SUBJECT: Calvert Cliffs Nuclear Power Plant
Units Nos. 1 & 2; Docket Nos. 50-317 & 50-318 Inservice Inspection
Program Request For Relief and Inservice Inspection Plans

ENCLOSURES: (1) Relief Requests for Calvert Cliffs Nuclear
Power Plant, Units 1 and 2

RELIEF REQUESTS FOR CALVERT CLIFFS

FIG. NB-3442.5-1 TYPE E PUMP

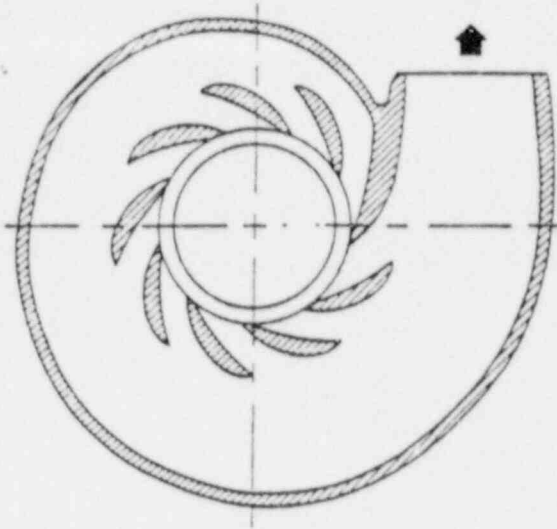
- A. The design configuration of each pump, as shown in Attachment (1), corresponds to a Type E pump illustrated in Figure NB-3442.5-1 (1977 Edition, ASME Code Section III). No practical technique exists to perform Inservice Inspection Radiographic Examination (RT) or Ultrasonic Examination (UT) of this type pump.

- A. The design configuration of the pump corresponds to a Type E pump illustrated in Figure NB-3442.5-1 (1977 Edition, ASME Code Section III). No practical technique currently exists to perform Inservice Inspection Radiographic Examination (RT) or Ultrasonic Examination (UT) of this pump type.

- A. One pump interior will be inspected to the extent practical (in recognition of the vanes therein) only if any pump be disassembled for any other reason.
- B. The reactor coolant pumps shall be hydrostatically tested per the requirements of ASME Code Section XI.
- C. A surface examination of one RCP in each unit shall be performed once each interval on the exterior casing weld surface areas by the liquid penetrant method.
- D. A visual examination of one RCP in each unit shall be performed once each interval on the exterior pump case surfaces.

COMBUSTION ENGINEERING DRAWING #233-415

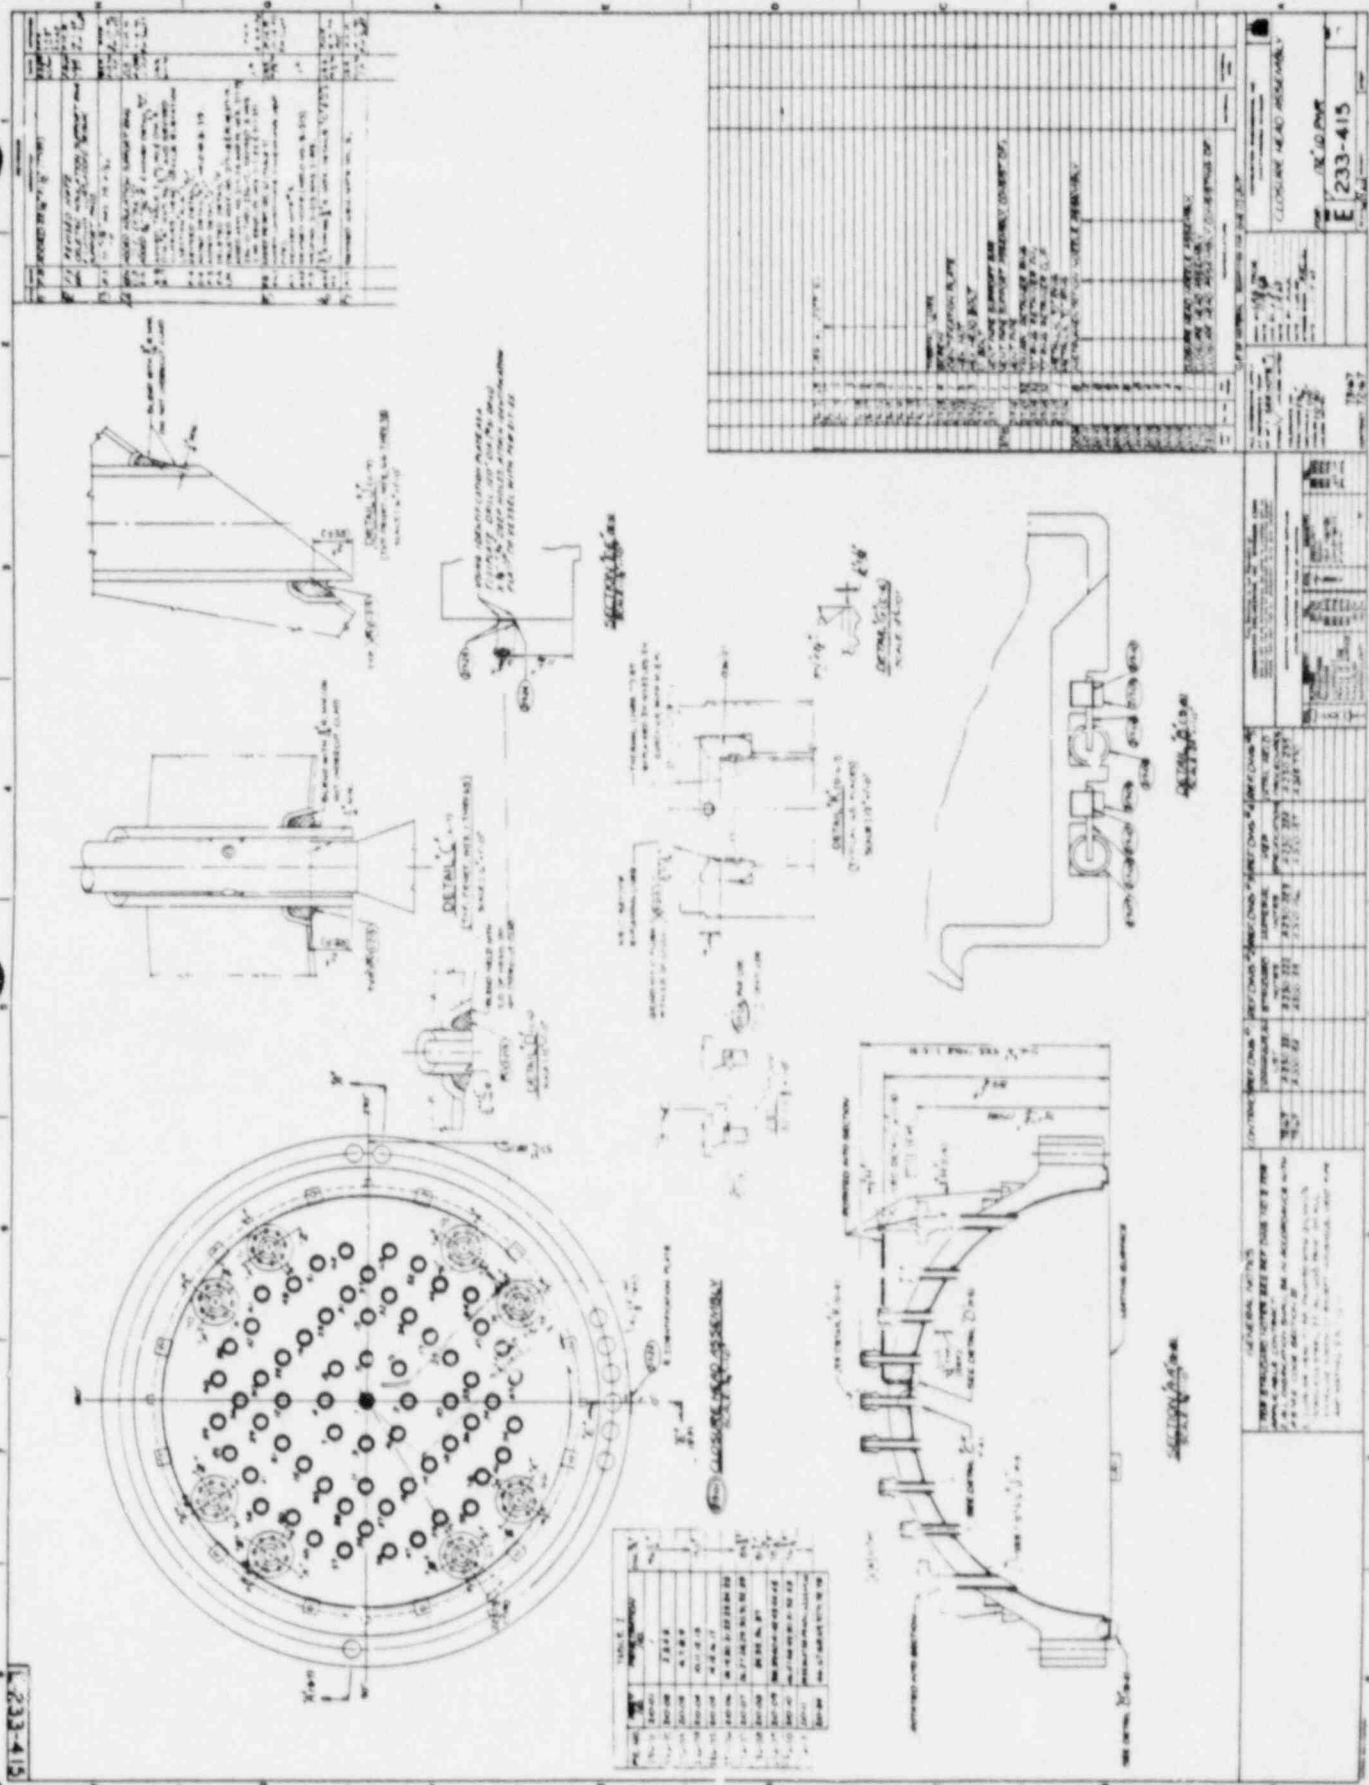
A 100% examination of these welds is impractical due to design configuration, accessibility limitations and material of construction. Reference Attachment (3) CE Drawing #233-415.

Ultrasonic examination will not provide meaningful results due to the geometric configuration of the joint and the material properties (Inconel-to-Stainless Steel welds). Radiographic examination cannot be performed due to the design configuration and accessibility. Therefore, a surface examination has been elected as the method of examination.

Three of the 28 peripheral CRD Housing welds should be examined to meet the Code. However, only a portion of each weld is accessible for examination since the welds are partially obstructed because they extend into the Closure Head itself.

In order to meet the intent of the ASME requirements, portions of additional CRD Housing welds will be examined to satisfy the equivalent of 100% of three welds. This will be done by examining 75% of three welds and 50% of two welds.
